**FINAL-ADDENDUM #3 TO BID #16-033**

BID NUMBER: 16-033

**PROCUREMENT FOR: Underground Steel Belted Conveyor System with Pit at MRF**

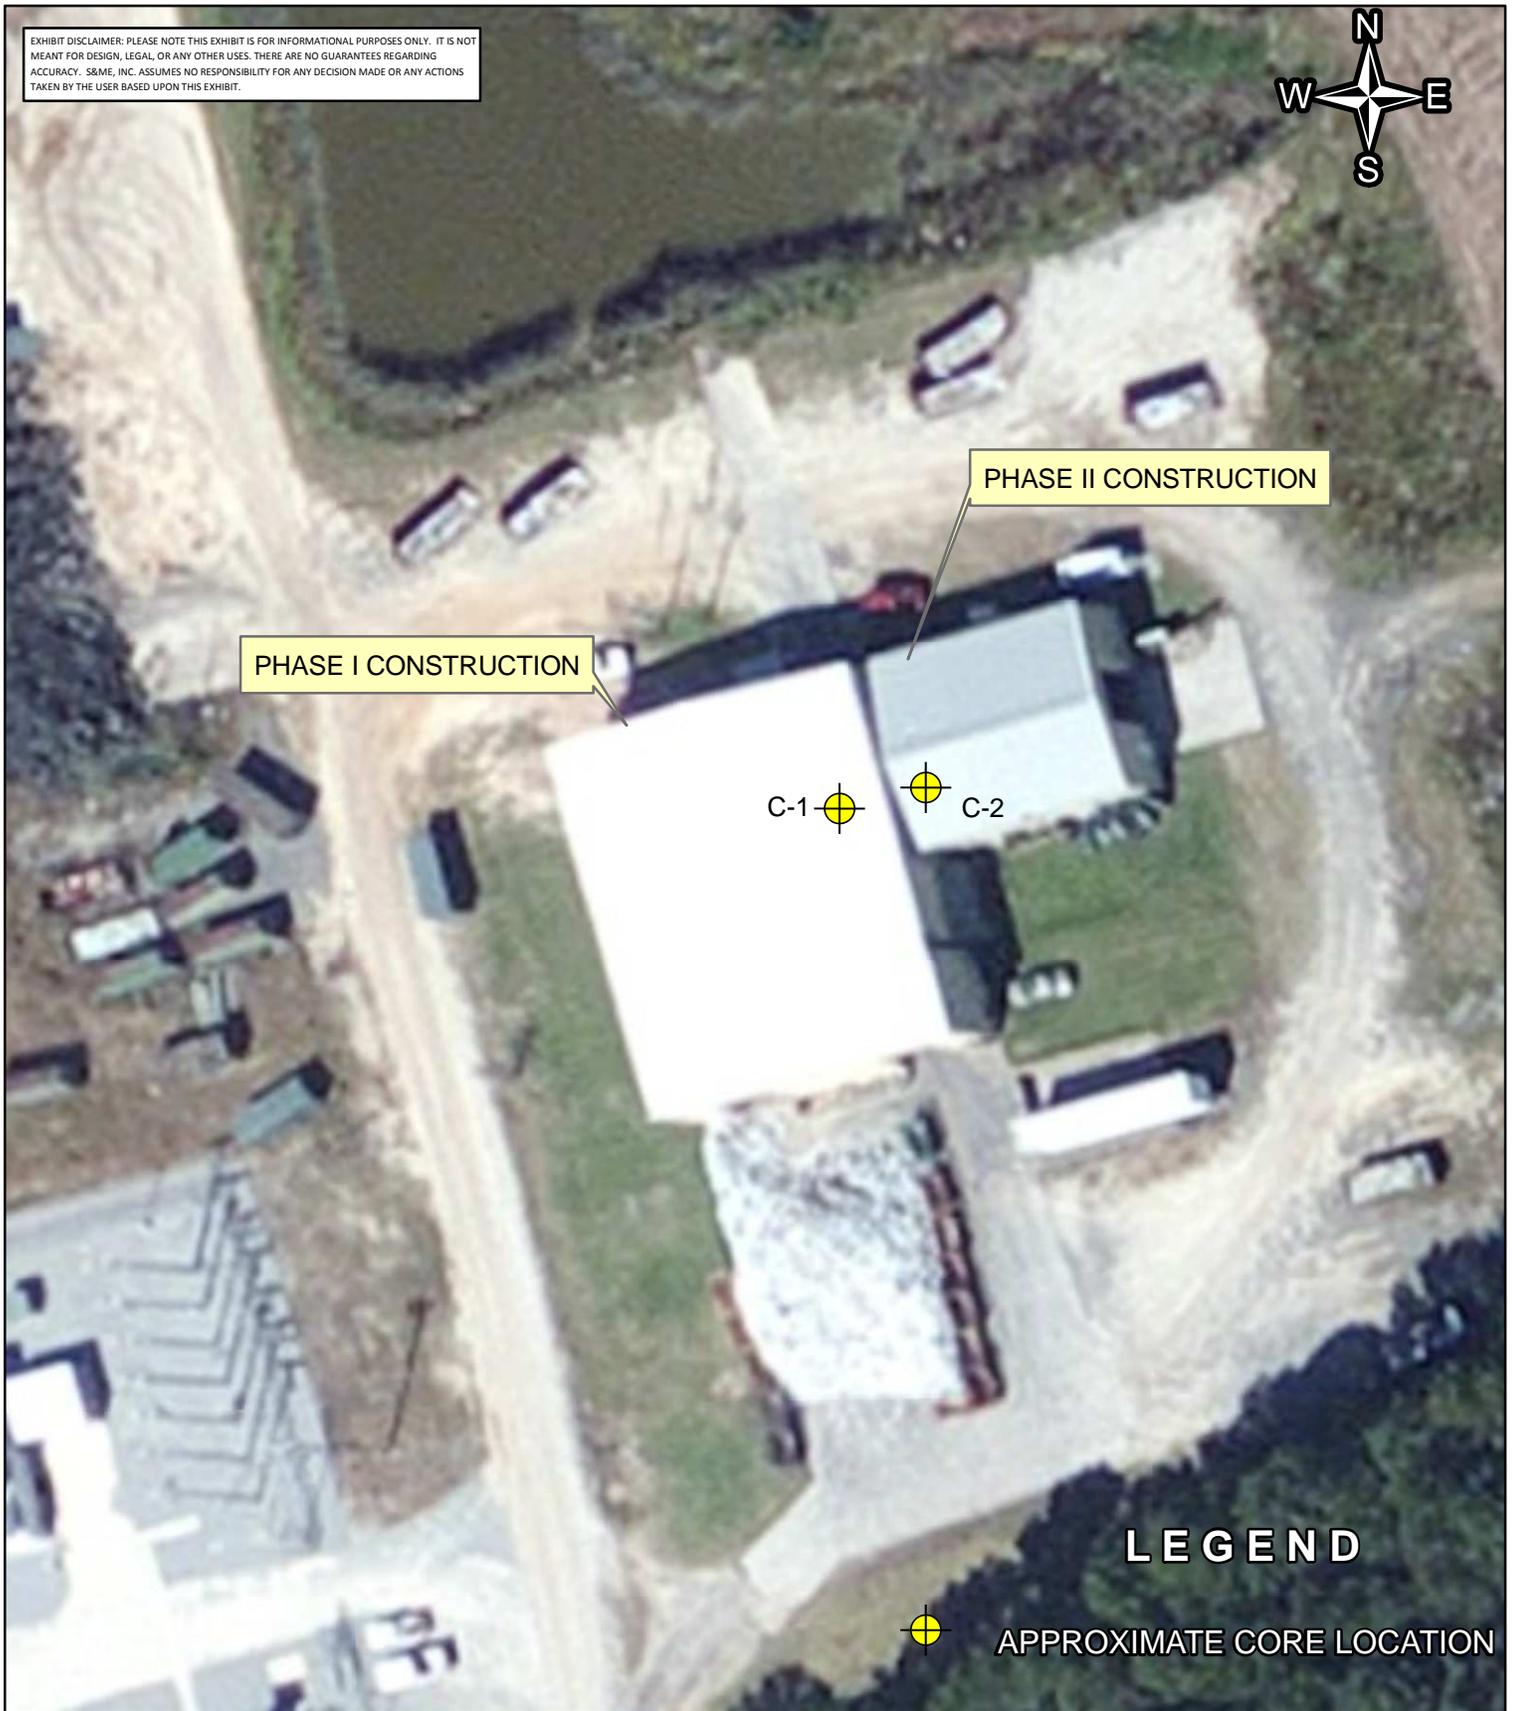
**Question 1:** What are the specs for the concrete/civil engineering, (i.e. thickness of concrete, reinforced)?

**Answer:** The County has requested concrete core testing from an outside firm in order to provide an accurate answer to this question. Please see the results from that testing attached. Please see below for the new bid opening date and time.

The field work for this project was performed on May 4, 2016. Upon arrival on-site Georgetown County personnel had pre-marked the desired test locations. The test locations were selected in the approximate vicinity of the proposed conveyor pit, on either side of the existing conveyor system. The approximate locations are indicated on Exhibit 1, attached to this report.

At each core location it was observed that there was an approximately 1 ½ inch void directly beneath the existing slab, as evidenced by the core dropping beneath the slab surface once the slab was penetrated. The individual thickness of each recovered core was measured and recorded, and these results are summarized in Table 1 below.

Test Location	Core Thickness (in)
C-1	7.0
C-2	6.49
